# CITY OF MILWAUKIE PLANNING COMMISSION MINUTES TUESDAY, June 27, 2006

New Safeway Fuel Station

TAR-06-01/TPR-06-05

Planning Commission Staff Report June 27, 2006

Figure 1 – Revised site plan with direct access to SE Harrison Street and SE 42<sup>nd</sup> Avenue.

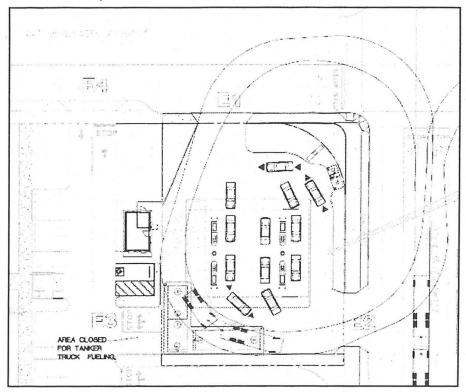
**Staff:** The applicant addresses the adverse impacts from the existing nonconforming driveway approaches but disregards the variance criteria, which requires that the adverse effects of the variance must be mitigated to the extent feasible. The continued use of multiple driveway approaches (Driveways E1 and E4 on Figure 1) on SE Harrison Street creates multiple safety hazards.

First, locating two driveway approaches (Driveways E1 and E4 on Figure 1) less than 50 feet apart would create conflicts between vehicles entering and exiting the two driveway approaches at the same time. Second, the provision of a separate gas station driveway approach (E1) on SE Harrison Street would create additional conflict points between pedestrians walking along the gas station and shopping center frontage and vehicles entering and exiting the site.

Moreover, any additional development that increases traffic on SE Harrison Street would add to the queue length and block driveway approach E1. Queues extending past the gas station driveway would restrict sight distance and may lead to aggressive driver behavior from increased delay.

The applicant is proposing one internal access driveway to the shopping center (see Figure 1 on the following page). Material provided by the applicant demonstrates that this internal driveway connection (E3) is adequate to serve fueling-vehicle circulation (see Figure 2 on the following page). The addition of a second internal access driveway (E5) on the east property line of the proposed development would provide adequate customer circulation and access on SE Harrison Street via the existing King Road Shopping Center driveway. This second internal access driveway should be placed at least 25 feet north of the south property line to provide for a one-car queue at the SE Harrison Street approach. This configuration would eliminate the need for

The Planning Commission finds that the applicant does not meet the variance criteria and denies the variance request to reduce the minimum distance between driveways and street intersection curb return of MMC Subsection 19.1413.2(E)(2) from the required 100 feet to 63 feet.

Figure 2 – Alternate site plan with shared access to SE Harrison Street.

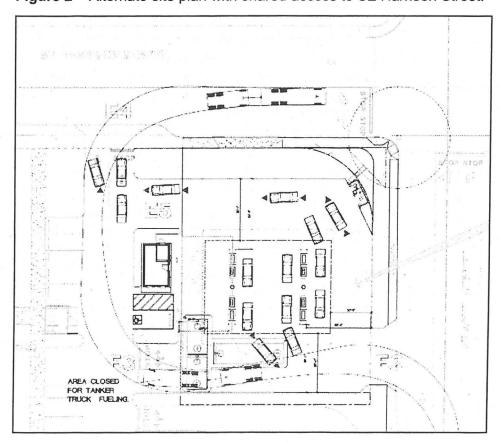
**Staff:** Upon staff request, the applicant submitted a site plan showing both driveways closed on SE Harrison Street and shared access with the adjacent shopping center property (see Figure 2 below, or Sheet B2 in Attachment 5 – Alternate Site Plan). This alternate site plan shows that there are feasible alternatives to the one currently proposed by the applicant.

- e. Construct a second internal access point (Driveway E5 on Figure 2) on the east property line 25 feet north of north right-of-way line of SE Harrison Street.

- f. Provide shared access onto SE Harrison Street via the existing King Road Shopping Center driveway approach (E4). Record a shared access agreement with Clackamas County.

Revised Site Plan

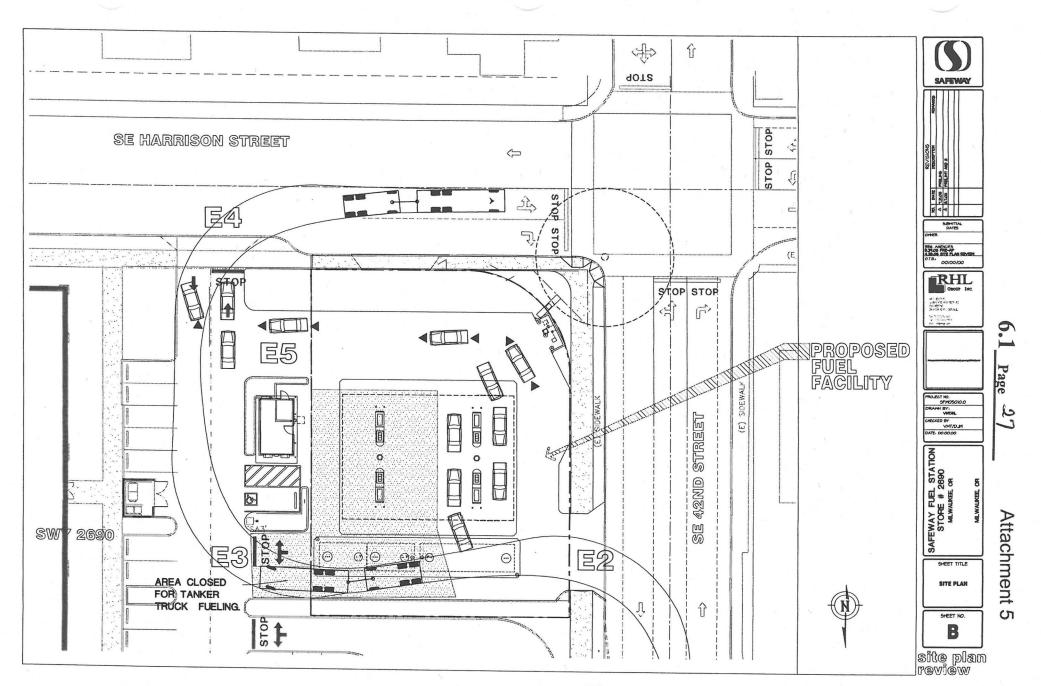
• [Staff Note on Comments from David Aschenbrenner, Chair of Hector Campbell NDA: Staff has since clarified Mr. Aschenbrenner's question with the applicant, who was under the impression that the proposed on-site parking space was required. In fact, the ADA-compliant space proposed next to the kiosk on the adjacent property will serve as the required parking space and will be shared as permitted by Subsection 19.503.2. The applicant has

revised the proposed site plan to reflect this clarification (see Attachment 4 – Revised Site Plan).]

Alternate Site Plan

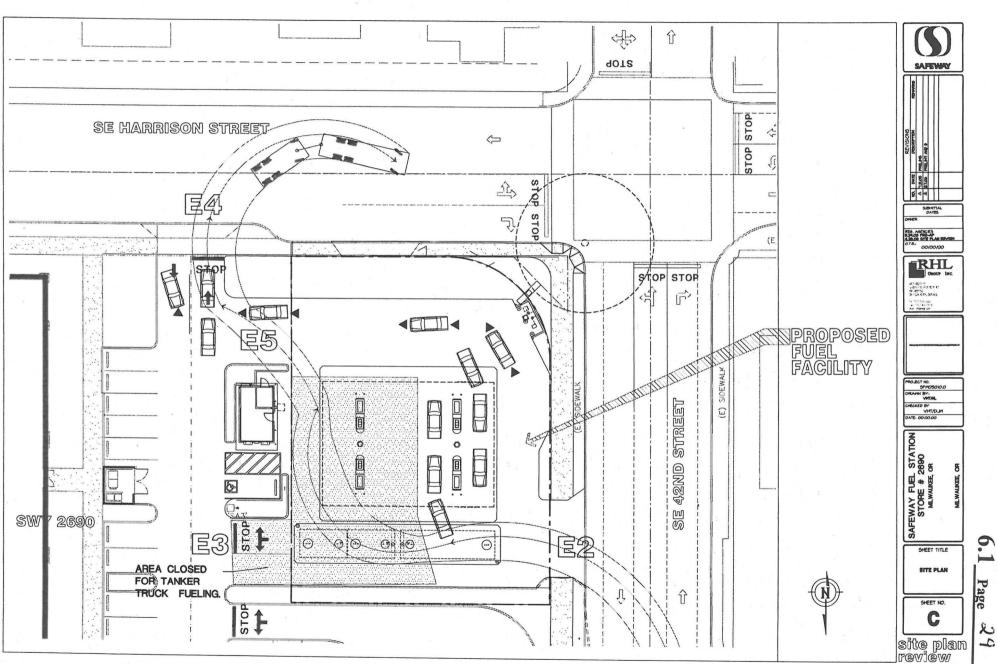
- 1. The fact that the subject property does not have enough frontage on SE Harrison Street to meet the 100-foot distance requirement for a driveway is not an unusual condition. The property is allowed—but is not entitled to—direct access onto SE Harrison Street, and staff believes that public safety would be better served by sharing access with the adjacent Safeway store.
- 2. The applicant has submitted an alternative site plan showing shared access onto SE Harrison Street that staff believes will work (see Sheet B2 in Attachment 5 Alternate Site Plan). Shared access may not produce ideal
